RESOLUTION NO. 5180-14

RESOLUTION APPROVING WITH CONDITIONS THE ARCHITECTURAL REVIEW APPLICATION FOR THE NYBERG RIVERS SHOPPING CENTER LOCATED AT 7455-7925 SW NYBERG STREET (TAX MAP 2S1 24 A, TAX LOTS 1601, 1602, 1900, 2502, 2506, 2507, 2508, AND 2700; TAX MAP 2S1 24B, TAX LOTS 2000, 2001, AND 2100 (AR-13-07)

PEDESTRIAN & BICYCLE PLAN

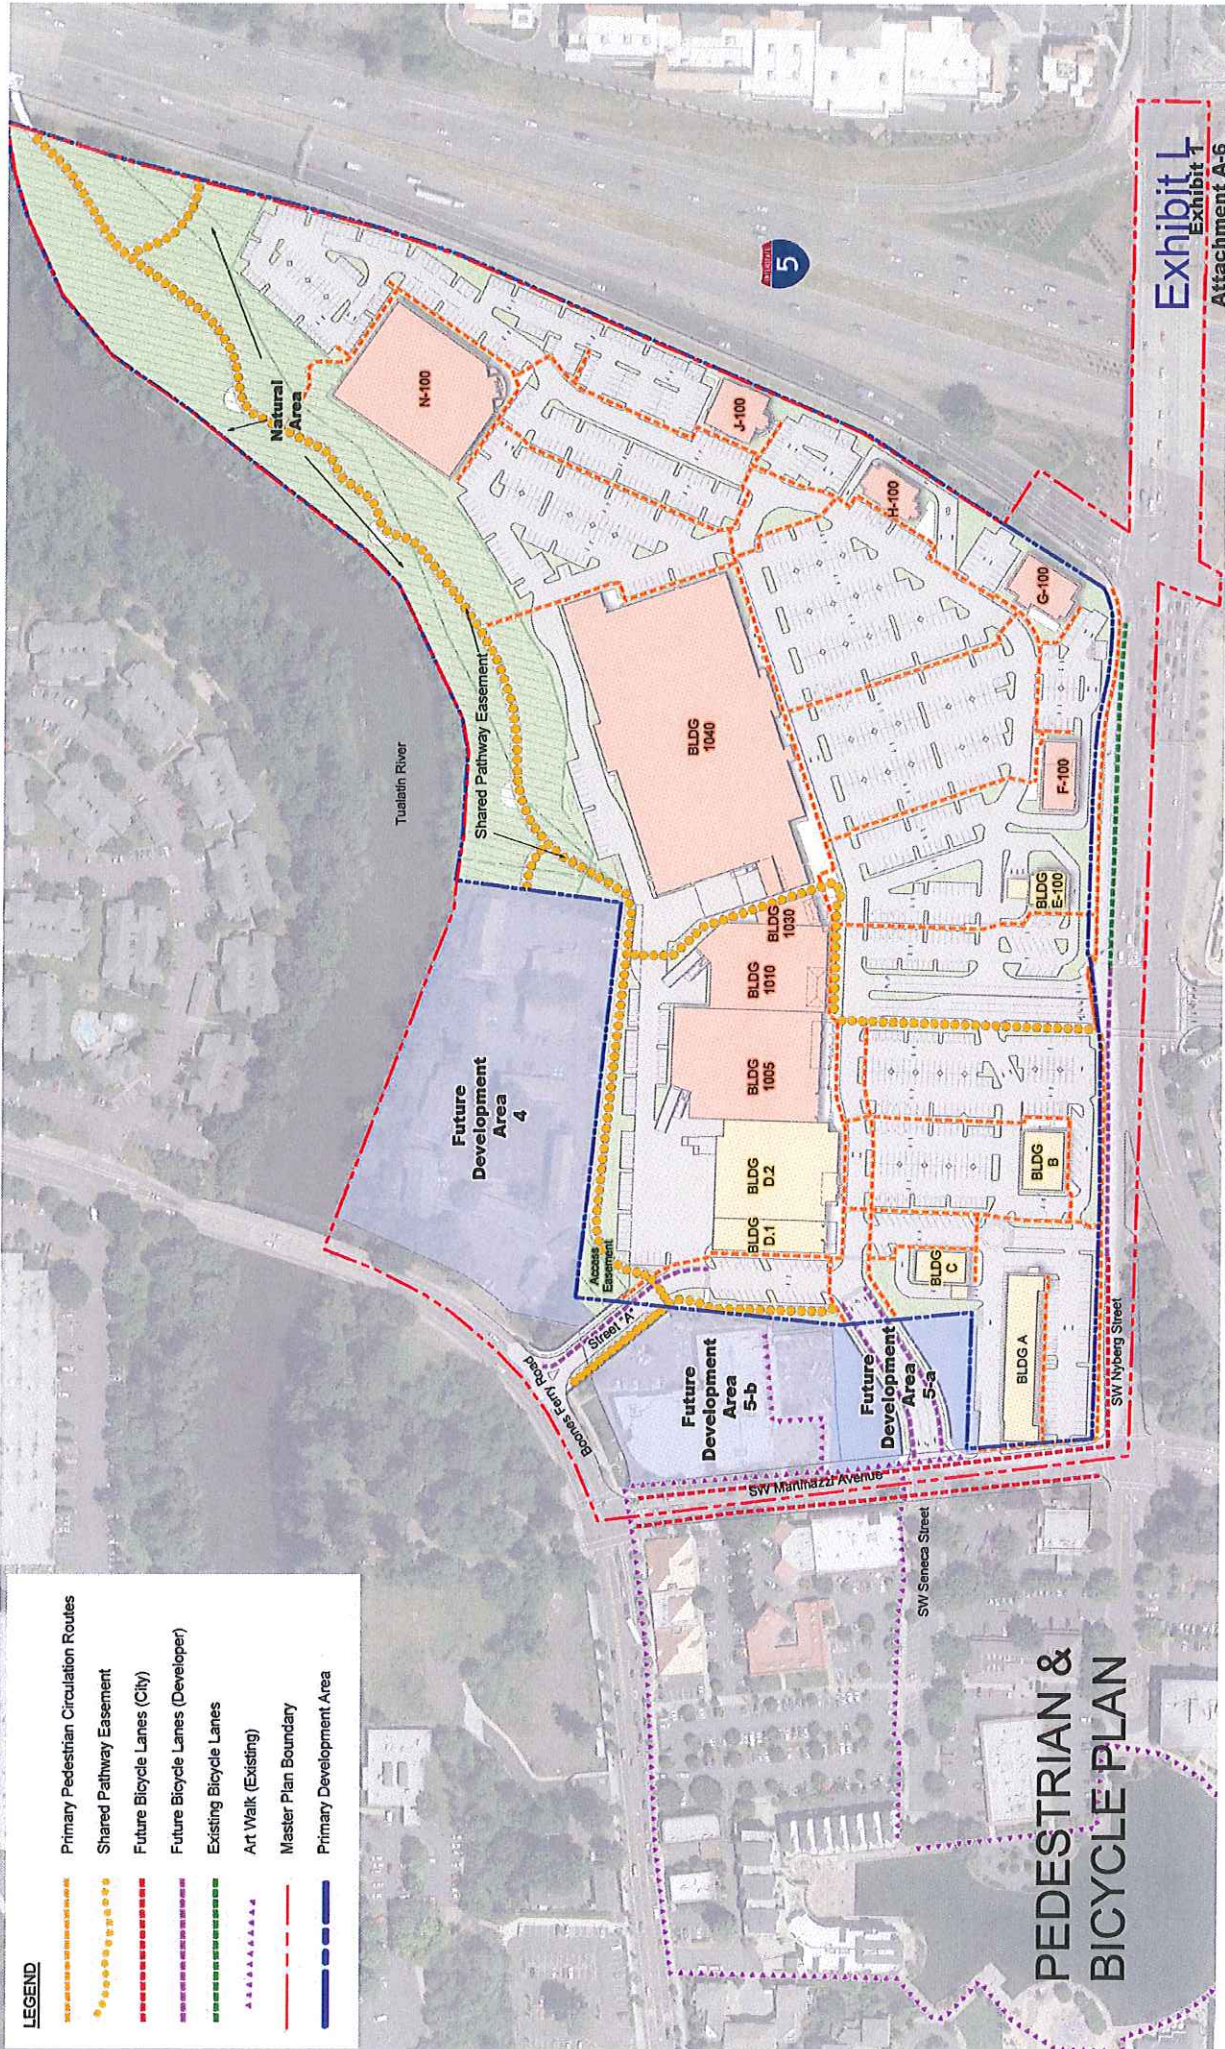
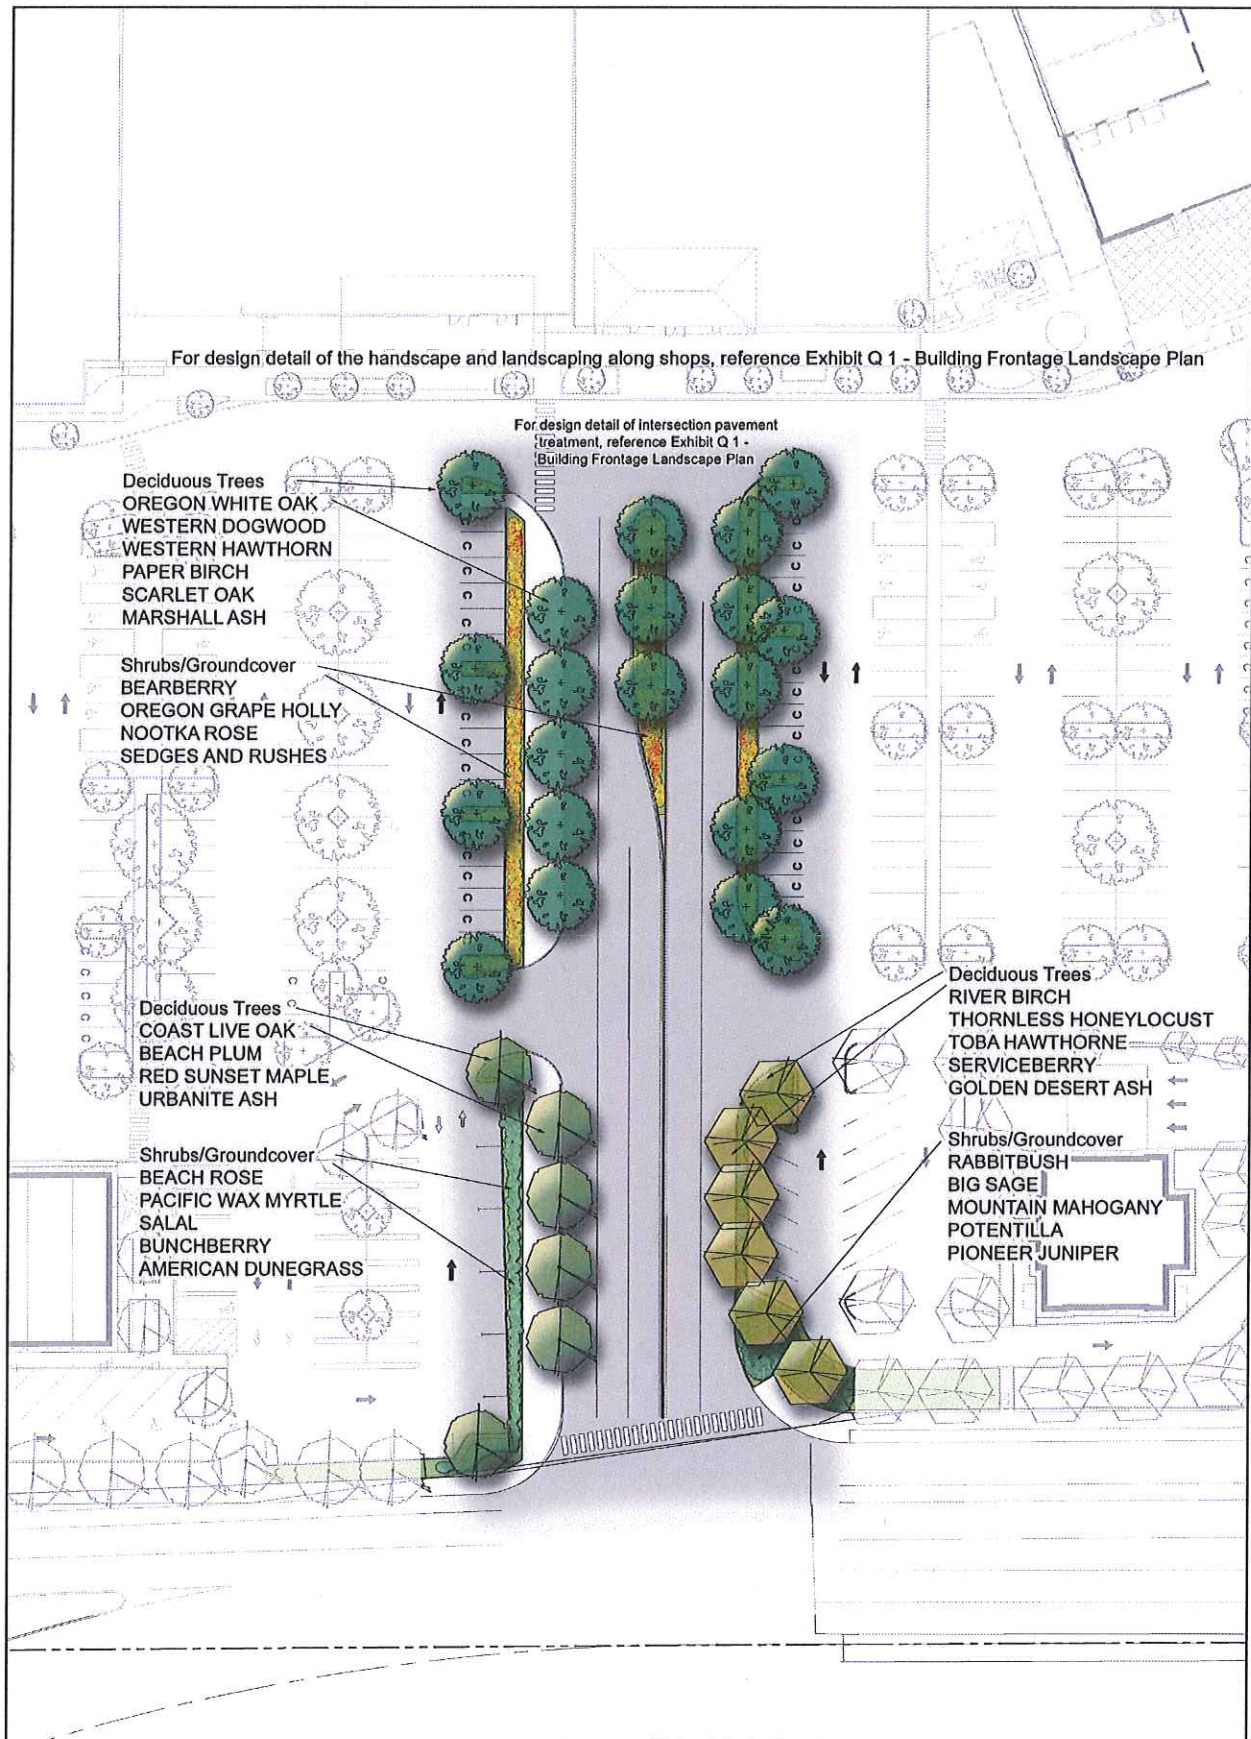
7. Exhibit A – Bicycle and Pedestrian Plan—from Engineering
a. Pedestrian and Bicycle Plan shows shared pathway easement connection to Heron's Landing on the east side, unlike the plans (C1.0). Plans do not show crosswalk at Boones Ferry Road crossing Street A.

- a. Pedestrian and Bicycle Plan shows shared pathway easement connection to Heron's Landing on the east side, unlike the plans (C1.0). Plans do not show crosswalk at Boones Ferry Road crossing Street A.

Response: Sheet C1.0 and the rest of the attached plan set have been revised to show the pedestrian and bicycle connections referenced above.
